L-2010-131
10 CFR 50.90

Re: Turkey Point Units 3 and 4
Docket Nos. 50-250 and 50-251
Response to 5/28/2010 Request for Additional Information (RAI) Regarding
Alternative Source Term (AST) License Amendment Request (LAR) 196
(TAC NOS. ME1624 and ME1625)

Response to 5/28/2010 Request for Additional Information (RAI) Regarding
Alternative Source Term (AST) License Amendment Request (LAR) 196

Figure 4-1

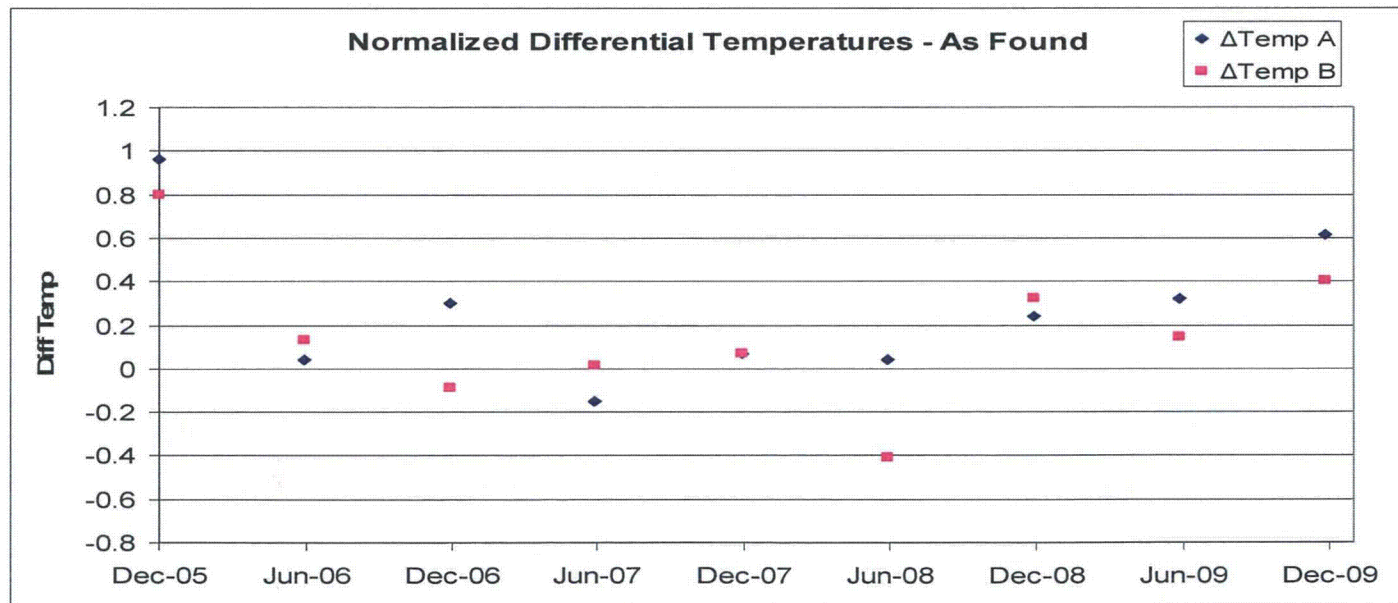
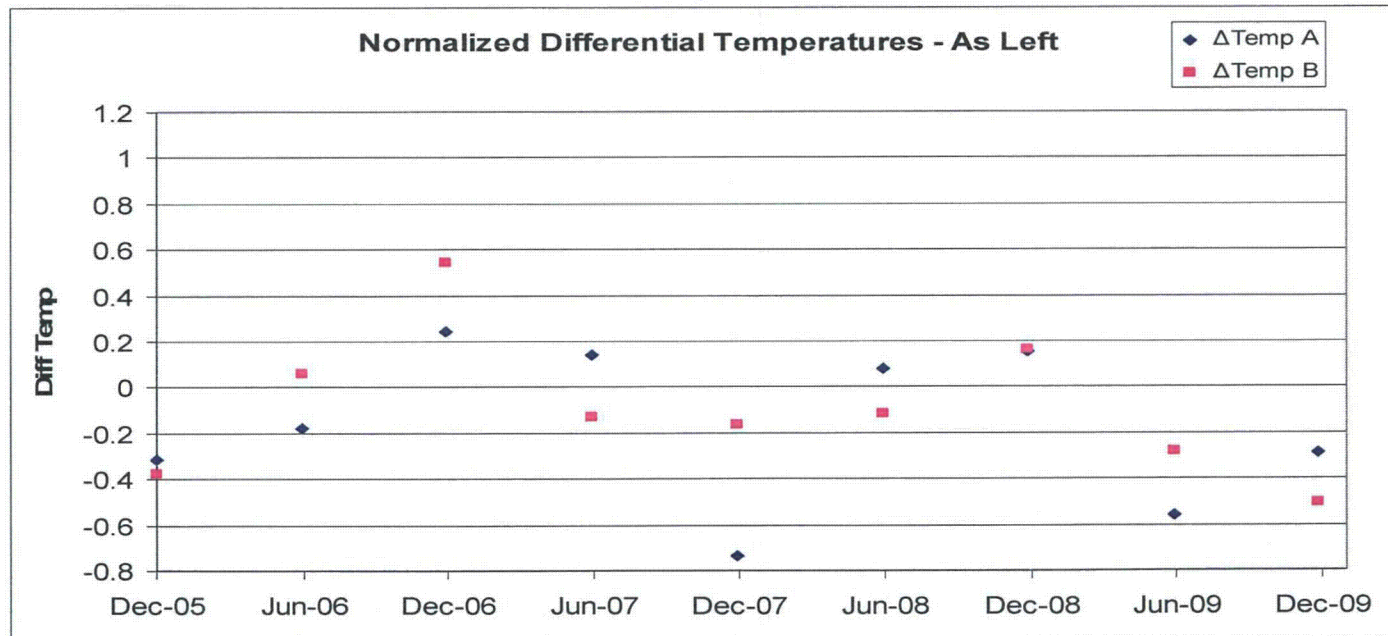
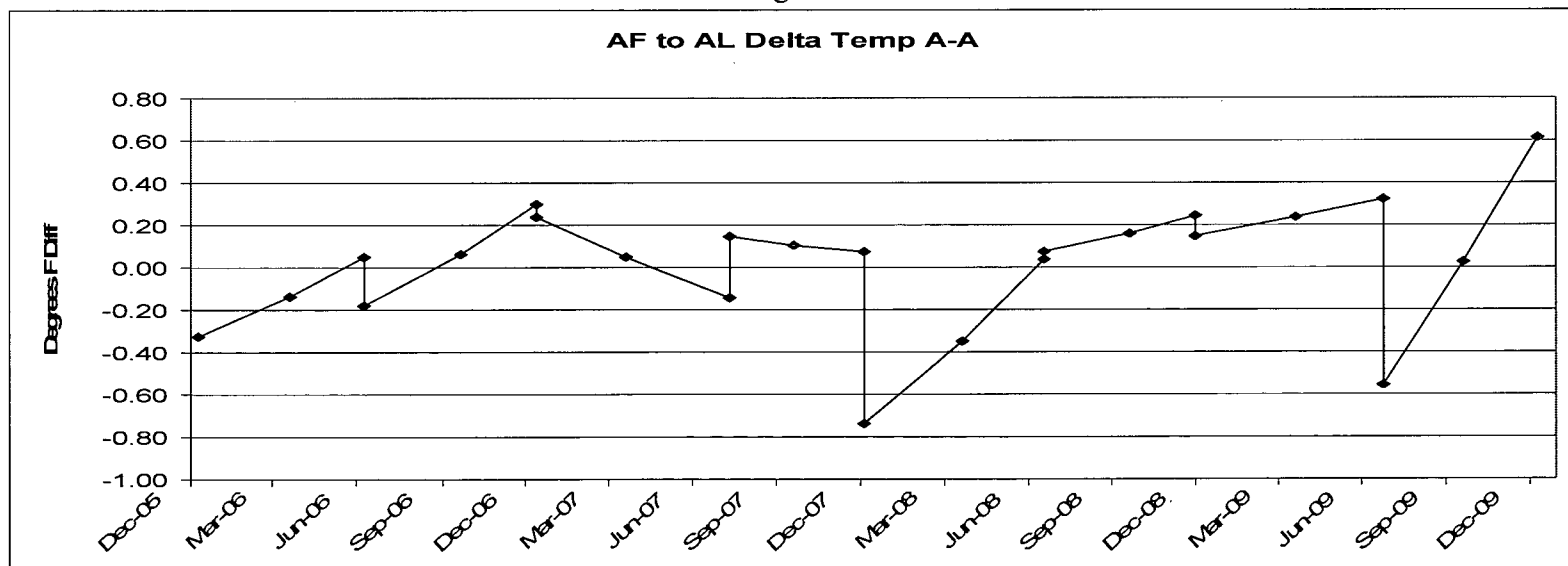
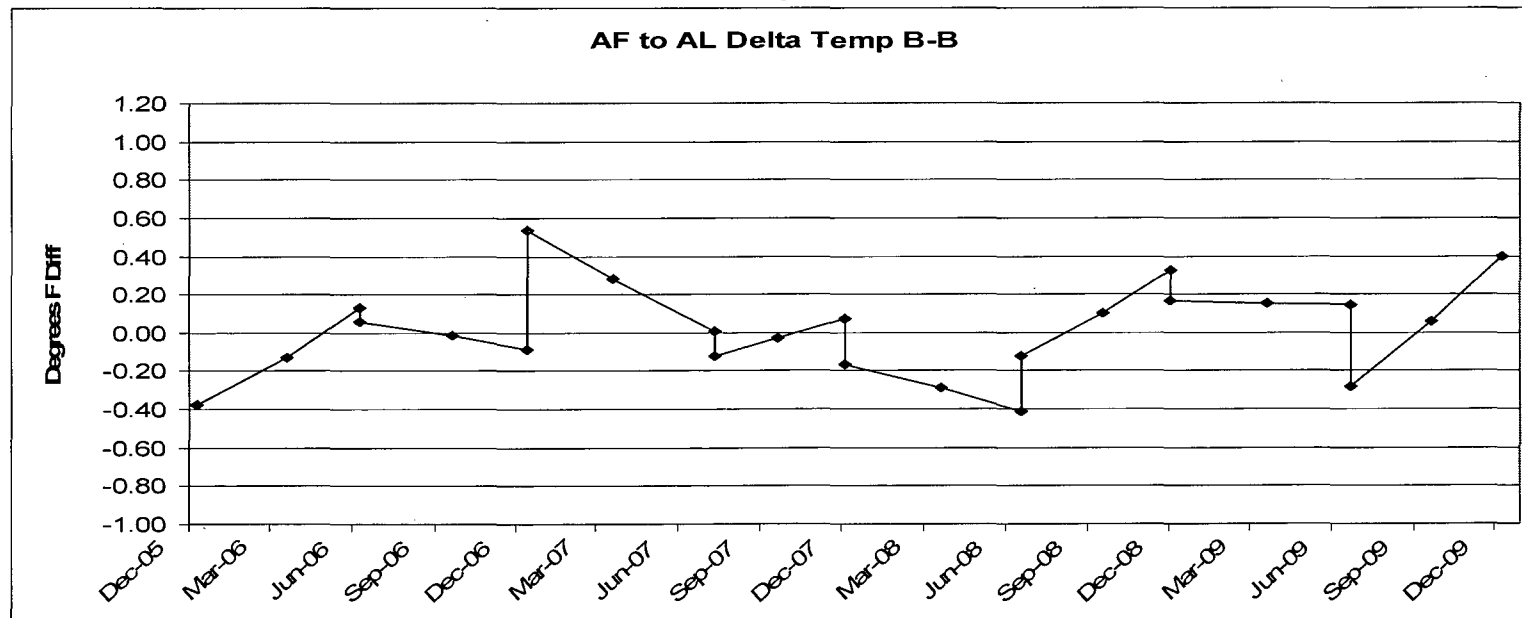
4. ***Regulatory Guide 1.23, "Meteorological Monitoring Programs for Nuclear Power Plants," states that vertical temperature difference accuracy should be within ± 0.1 °C (± 0.18 °F). Were each pair of temperature sensors used to make measurements of temperature difference as a function of height calibrated jointly as a pair? This would include pairing of one temperature sensor with another temperature sensor of another pair, if one sensor of a set pair was unavailable.***

The meteorological temperature instrumentation is calibrated and replaced on a six month interval using approved plant procedures. The temperature instrumentation (2 @10m and 2 @ 60m) is calibrated in a series of sequential and overlapping tests. The temperature elements (thermistors) are initially verified for range and accuracy with an acceptance criterion of ± 0.9 °F in a Measurement & Test Equipment (M&TE) dry well calibrator. The temperature elements are then installed in the tower and the ambient temperature loop instrumentation, from the tower to a CR1000 data logger, is procedurally verified to be within ± 0.9 °F of the M&TE readings using a handheld digital M&TE thermometer. The in-situ data taken (5 data points) is averaged and compared to the averaged M&TE readings. Another verification of the ambient and differential temperature data is performed utilizing an electronic check between the data logger, the plant ERDADS computer, and the control room recorder. A final loop integrity check is performed and documented.

A review of the as-found/as-left meteorological ambient temperature loop data taken for 2005-2009 was performed (see Tables 4-1 & 4-2 below). The temperature data for June 2005 was not retrievable. The as-found data for December 2005 and June 2009 for the 10m temperatures were determined to be slightly low and out of the 0.9 °F tolerance. The remaining as-found and all of the as-left data for this period were within ± 0.9 °F.

The differential temperature data is digitally calculated by comparison of the ambient temperatures within the data logger at the meteorological tower. The data is calculated from paired temperature elements (60m-10m), A-A and B-B, and digitally transmitted to the ERDADS computer. A review of the differential temperature data was performed using the as-found/as-left data from the ambient temperature calibrations and calculating the respective temperature differentials (see Tables/Figures below). For December 2005, the differential temperature readings were uncharacteristically high due to the out-of-tolerance ambient temperature as-found data for that calibration date. It was noted that approximately 50% of the as-found/as-left data fell within the ± 0.18 °F criteria specified in Regulatory Guide (RG) 1.23, Rev 1, Meteorological Monitoring Programs for Nuclear Power Plants [Reference 12] while approximately 90% of the data fell within ± 0.54 °F.

As shown in Tables/Figures 4-1 and 4-2 above, meteorological tower ambient temperature instrument accuracies are generally within the $\pm 0.9^{\circ}\text{F}$ of M&TE as specified in RG 1.23. However, the instrument accuracies for the vertical temperature differences are often outside of the $\pm 0.18^{\circ}\text{F}$ specified in RG 1.23. The vertical ΔT measurement is important as it is the preferred method for determining the Pasquill stability classes at nuclear power plants for licensing purposes because it is an effective indicator for the worst-case stability conditions. The stability class is an indication of atmospheric stability or the amount of turbulent mixing in the atmosphere and its effect on effluent dispersion.

As shown above, the as-found and as-left temperature readings for both channels at both elevations are “normalized” against their corresponding M&TE readings ($\text{Temp} - \text{M\&TE}$). The vertical temperature difference (ΔT) for each channel is then calculated by subtracting the normalized channel temperature at 10 meters from the normalized channel temperature at 60 meters ($T_{60} - T_{10}$). The resulting ΔT values are the as-left and as-found normalized ΔT values for each channel that define the instrument accuracies between the calibrations, i.e., beginning with the as-left values and ending with the as-found values over the six month calibration interval. During this period, the instruments will experience some drift which, for purposes of this discussion, has been assumed to be linear in its behavior. Thus, as shown in Tables/Figures 4-3 and 4-4 above, a six month representative ΔT value can be derived by taking the average of the beginning and end ΔT values for each temperature channel. When the ΔT is within the $\pm 0.18^{\circ}\text{F}$ specified in RG 1.23, no adjustment to the meteorological data would be considered necessary. However, since the ΔT values have been observed to be outside of this accepted range, the averaged ΔT value for each channel will be applied as a bias or correction factor to the hourly meteorological data. The effects of this correction will be small shifts in the calculated stability classes for the hourly meteorological data and result in small changes to the calculated atmospheric dispersion factors (X/Q_s). When the resultant biased X/Q values exceed the unbiased X/Q_s , the more conservative value will be used. This technical approach will assure conservative radiological dose consequences for the analyzed design basis accidents.

Turkey Point "MSI QA File" - 2005
Alpha minus Bravo dT (°F) @ 60 Meters
and
Alpha minus Bravo dT (°F) @ 10 Meters

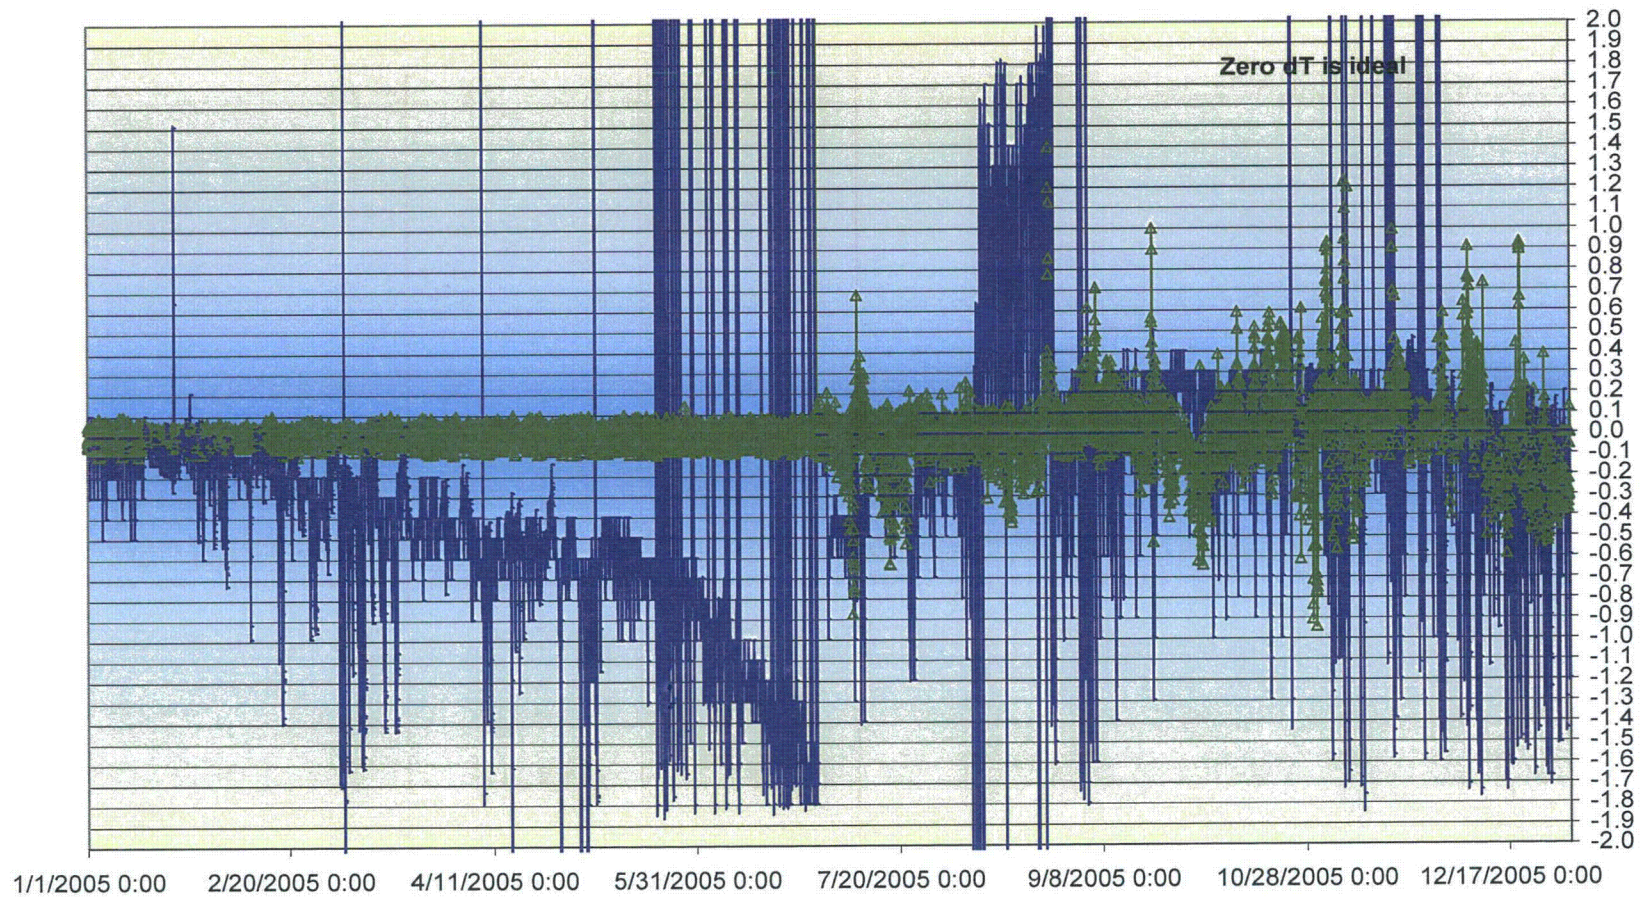
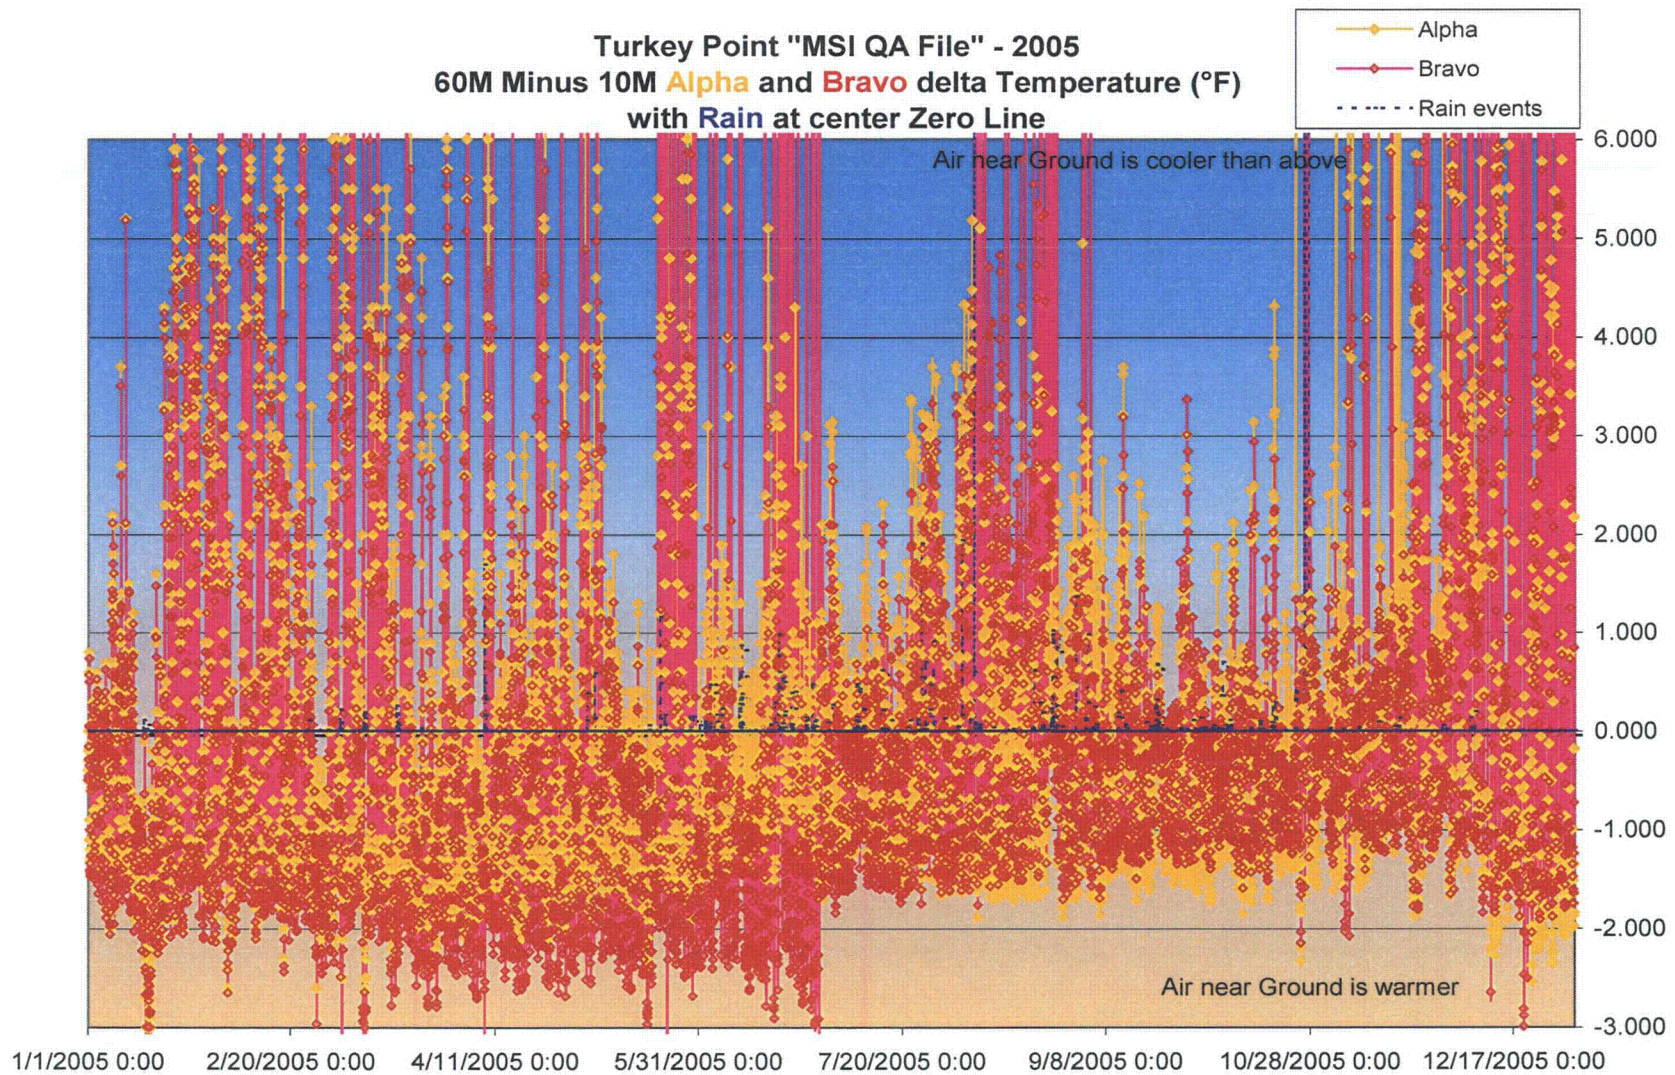
3. *Page 12 of the enclosure to the April 14, 2010 response states that in some cases, substitutions were made when there was a considerable amount of invalid data from the primary measurement trains. Were substitutions made for infrequent random occurrences of a few hours duration? Does the discussion at the top of page 13 summarize all of the substitutions? Were the temperature difference data in the computer input files for 2003, the second half of 2004, the second half of 2005, the last three quarters of 2006, and 2007, other than August through October, inclusive, essentially all measured only on the primary tower?*

Julian Date 2005	Time	Parameter	Reason	Action	NAI Review
357 357-358 358 358-359 361-362 364 364-365	1800 2200-0000 0200-0500, 0700-0800 1800-0600 1700-0300, 2100 0400,0700 1900-0700	WSPD: HEIGHT= 10.0 M	Choice of treatment of 0.0 wind speed value	MSI substituted 9999's (indicating bad reading or failed sensor) for 0.0 "raw data" wind speed. NAI will resolve this differently than MSI for the following time periods. NAI review of the raw data, and review of the corresponding Land Use data indicates very low wind speeds are reasonable. 357-359 Likely Calm, not missing 361-362 Likely Calm, not missing 364 Likely Calm, not missing 365-365 Likely Calm, not missing	NAI cannot confirm that this "bad data" flag application is appropriate. Wind speeds of 0.0mph are valid readings for calms, and would be counted for input to ARCON96, along with other JFD data.
1Q05-2Q05		10M Temperature – A-B Delta-T	Unknown	NAI review of this plot, plus the plot on next page (60M – 10M Alpha vs. Bravo Delta Temperature) indicates that the trend in 10M A-B delta-T is likely due to drift in the Bravo channel (see yellow/Alpha line in second plot – no trend; while pink/Bravo line gets a step "correction" at end of 2Q2005), so the NAI implementation of A-Delta-T based stability calculations will eliminate any problems the drifting B channel might have introduced. No further investigation needed.	NAI Identified: See accompanying plot that shows significant trend in 10M Temp A-B Delta-T. This trend may affect choice of A or B channel for determining Stability.
